## **NFPA Technical Committee on Standpipes (SPI-AAA)**

### **NFPA 14 FIRST DRAFT MEETING AGENDA**

### **NFPA 14 PRE-FIRST DRAFT MEETING MINUTES**

**FIGURE A.16.12.5.5(a) Fire Department Connection to Underground Piping for a Single System.**

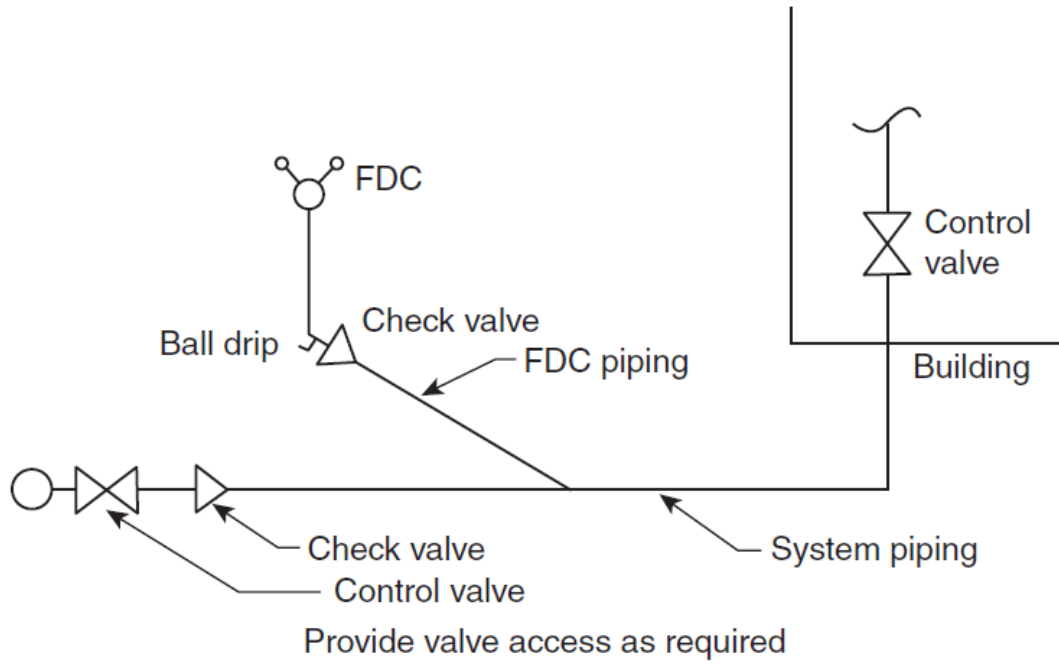
Figure A.6.4.3.1 illustrates a fire department connection connected to the underground piping.

Rename as A.6.4.3.1

**Figure A.7.10.1.2.1.1 Standpipe System with Risers Terminating at Different Floor Levels.**

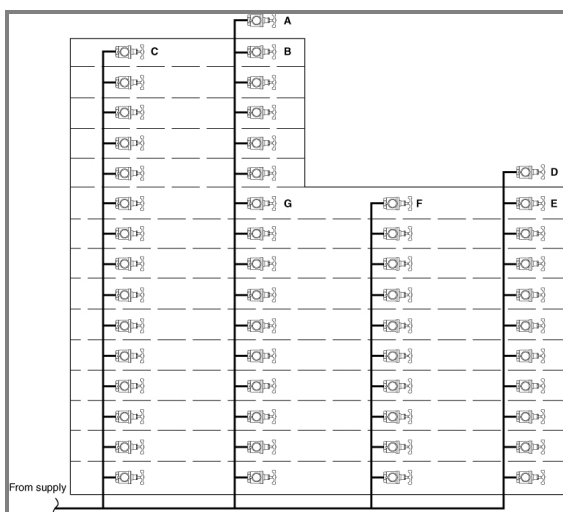
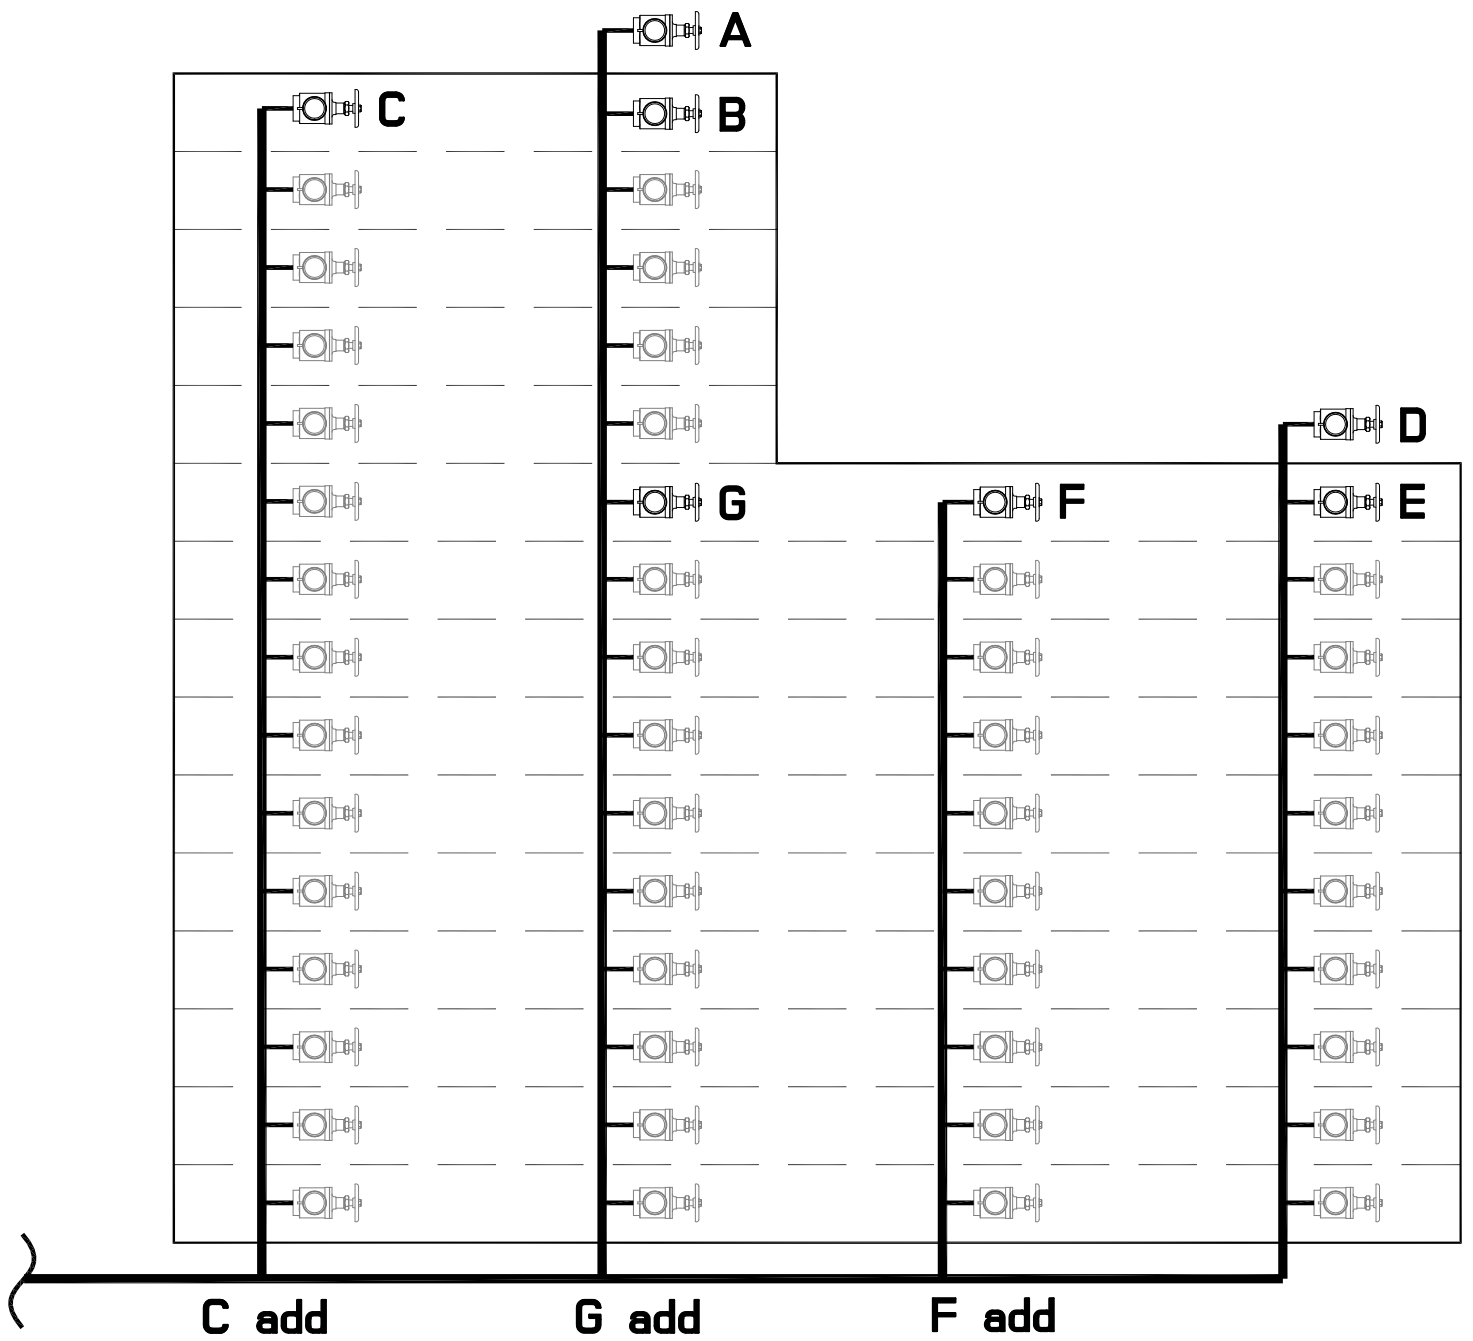
For example, consider the standpipe system shown in Figure A.7.10.1.2.1.1 with two risers that terminate at the 15th floor and roof and two risers that terminate at the 10th floor of and lower roof of this fully sprinklered high-rise building. In this case, two separate hydraulic calculations need to be performed. The first would verify that the system can deliver 100 psi (6.9 bar) to the top of the risers on the 15th floor with the upper roof with a total of 750 gpm (2840 L/min) flowing [250 gpm (946 L/min) each at points A, B, and C Add]. The flow and pressure will be available at the location of hose connection C. Only the gallage for hose connection C needs to be added at the connection to the supply piping. The second calculation would need to prove that the system can deliver 100 psi (6.9 bar) to the 10th floor with the lower roof with a total of 1000 gpm (3785 L/min) flowing [250 gpm (946 L/min) each at points D, E, F Add, and G Add]. Note that since the building is sprinklered, there is no flow required from the fourth riser in this second calculation.

This PI modifies the language and the Figure to clarify where the additional standpipe flow needs to be added.

<u>File Name</u>	<u>Description</u>	<u>Approved</u>
Hydraulic_Calc_Figure_A.7.10.1.2.1.pdf	Revised Figure A.7.10.1.2.1.1
